GATWICK AIRPORT NORTHERN RUNWAY PROJECT

ISSUE SPECIFIC HEARING 8

POST-HEARING SUBMISSION ON AGENDA ITEM 8: DRAFT DEVELOPMENT CONSENT ORDER

POST HEARING SUBMISSIONS INCLUDING WRITTEN SUMMARY OF THE LEGAL PARTNERSHIP AUTHORITIES' ORAL CASE

For instance, Sheet 5 of 7 (Drawing number 20000-XX-A-XXX-GA-990006 (revision P03)) shows the location of Work No. 4a-f, h, i, j as follows –

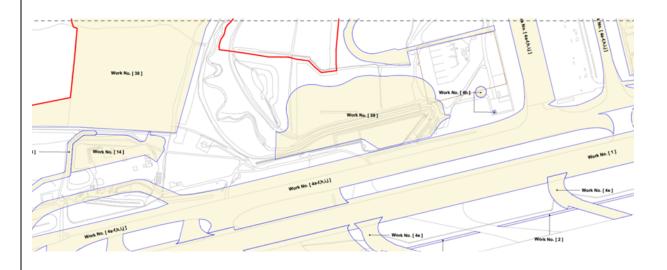
The concern with Work No.4 is primarily with the Work Plans [REP5-016].

The Authorities consider it would be helpful, from a development management perspective, if the drawing (and adjoining sheets) showed each element of Work No. 4(a)-(f), (h),(i), (j), separately.

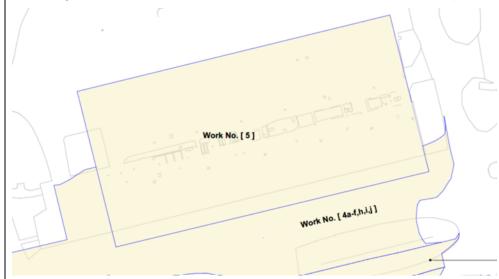
Regarding Work No.5(a) to (g), the same point applies as in respect of the above-mentioned elements of Work No.4: the JLAs consider it would be helpful if each element of that work was shown on Sheet 3 of 7 of the Works Plan (Drawing number 20000-XX-A-XXX-GA-990004) (revision P04). At present Work No.5 is shown as –
